CITY OF PROVIDENCE, RHODE ISLAND

RFP Title: Site Improvements at Gano Street Park

Addendum #: 2

SITE IMPROVEMENTS AT GANO STREET PARK

Existing Conditions Plan

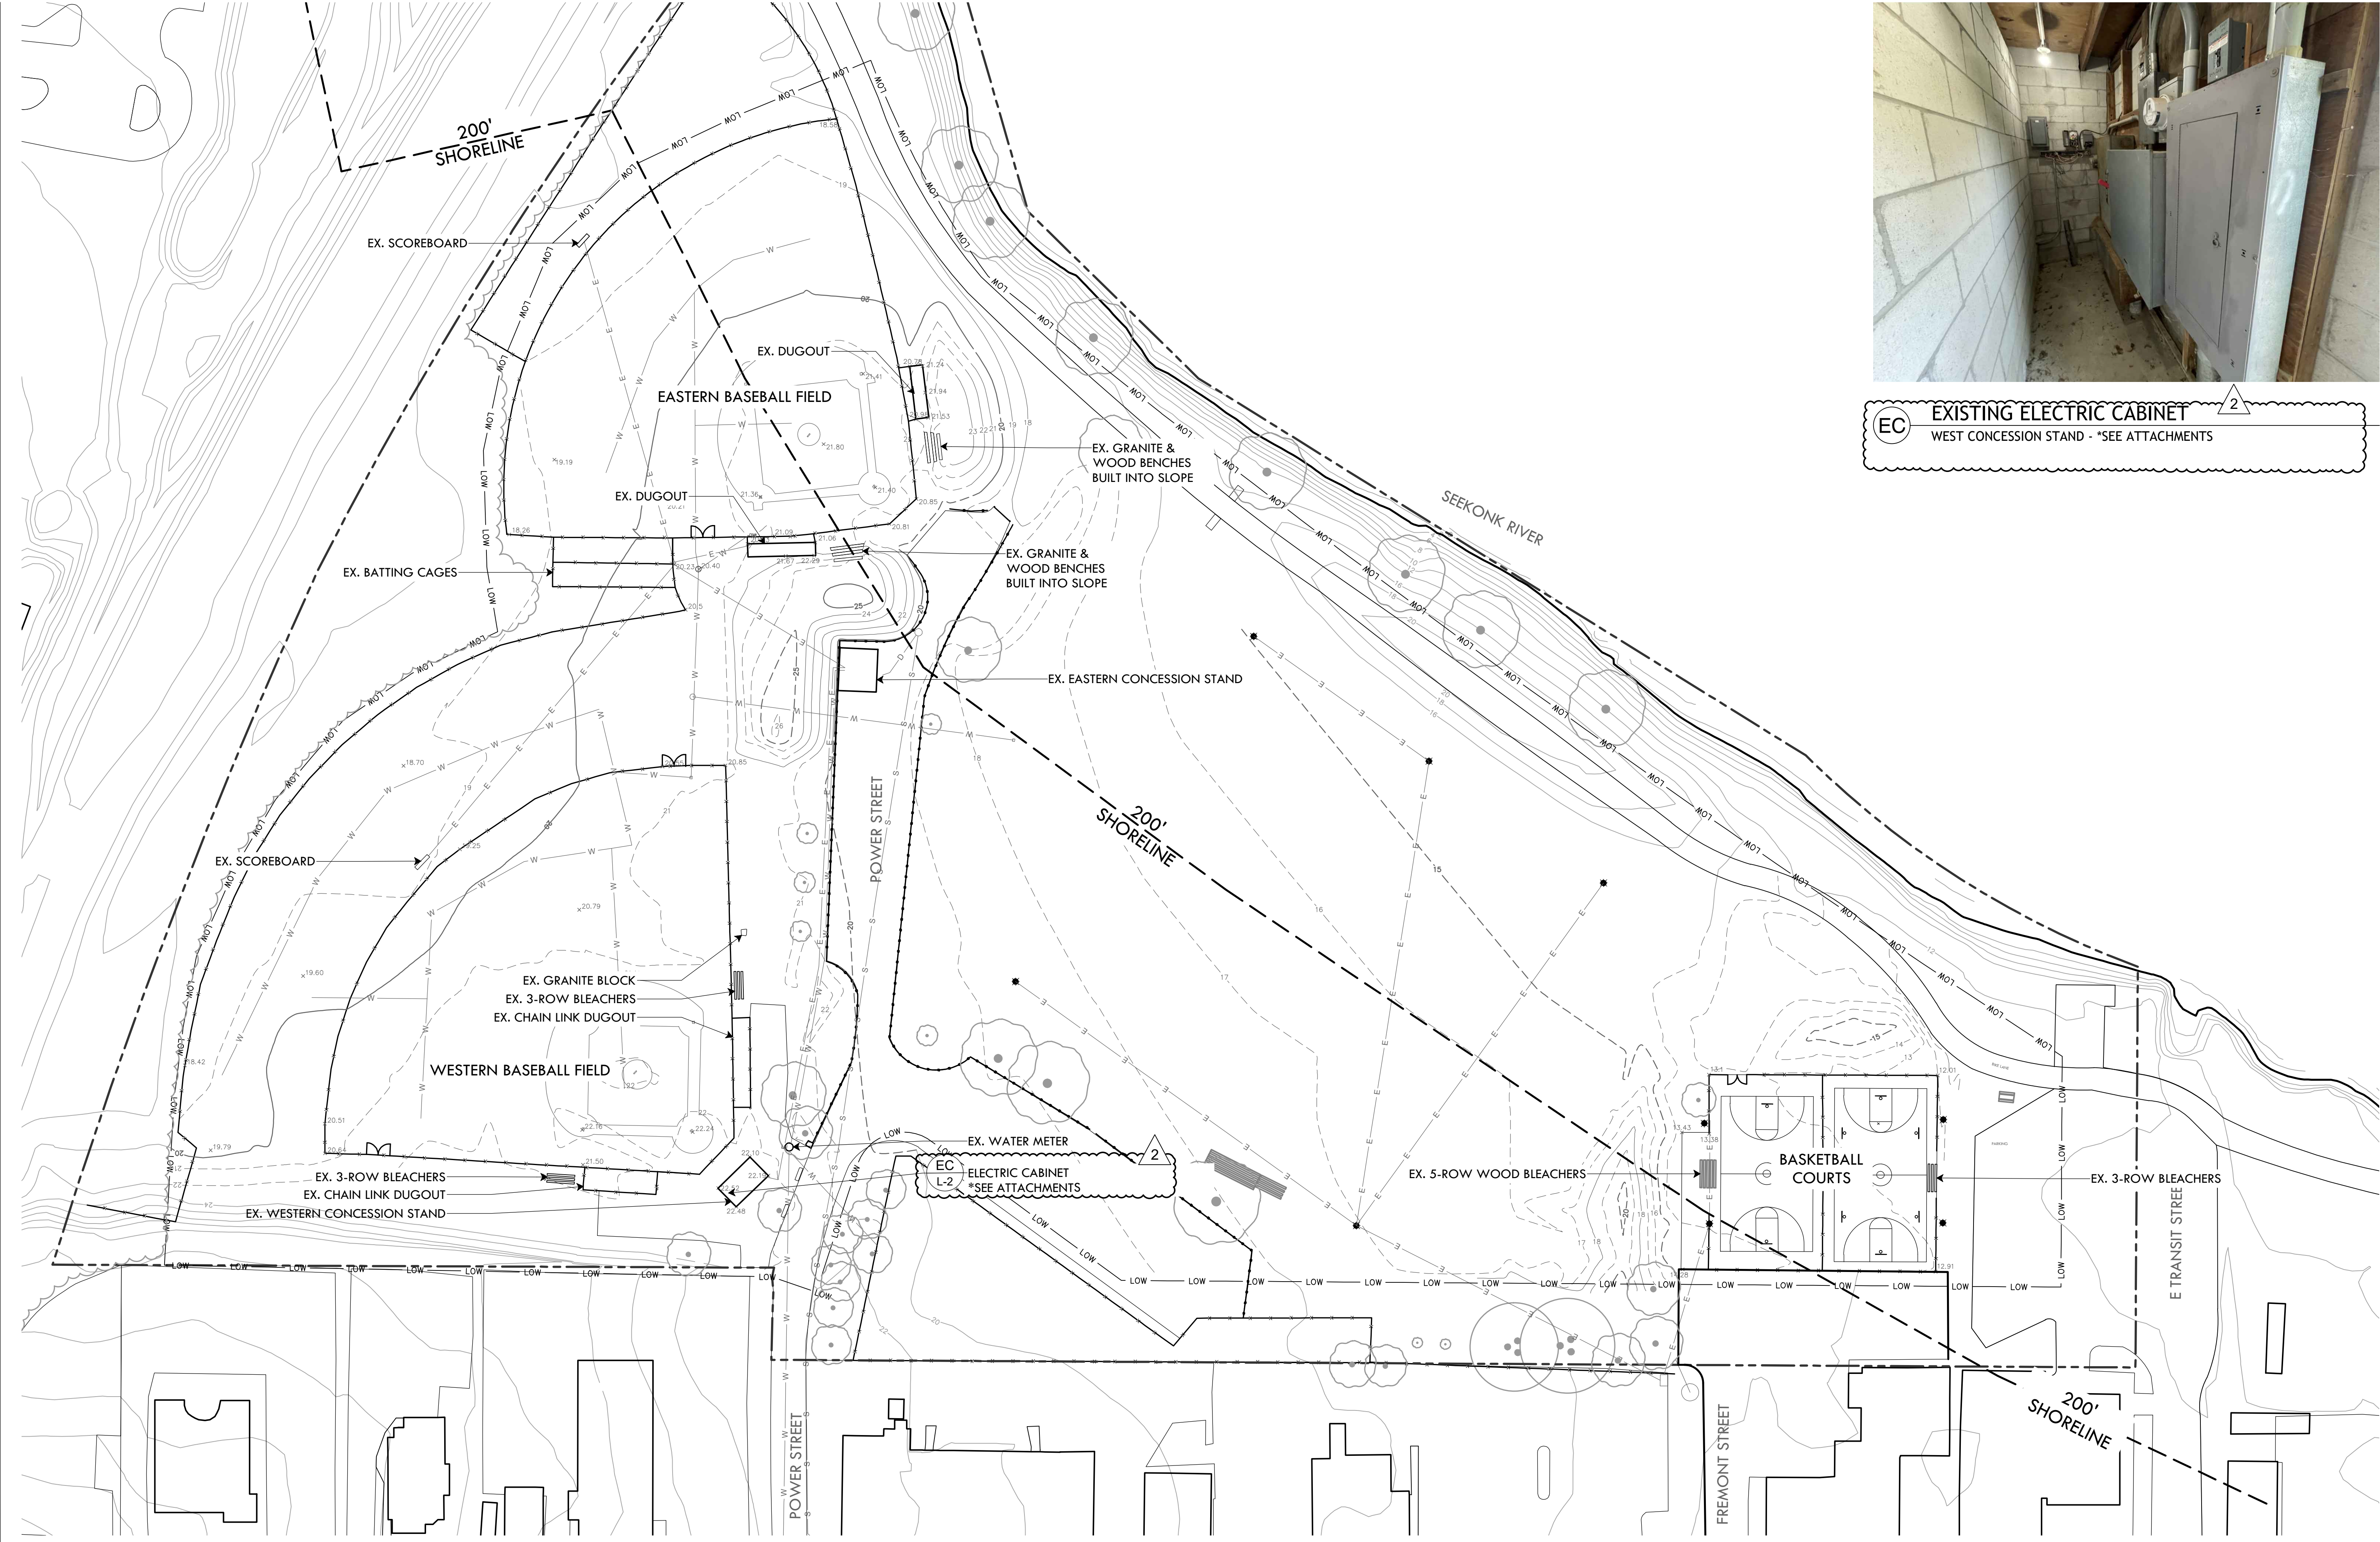
EC EXISTING ELECTRIC CABINET
WEST CONCESSION STAND - *SEE ATTACHMENTS

EC L-2 ELECTRIC CABINET
*SEE ATTACHMENTS
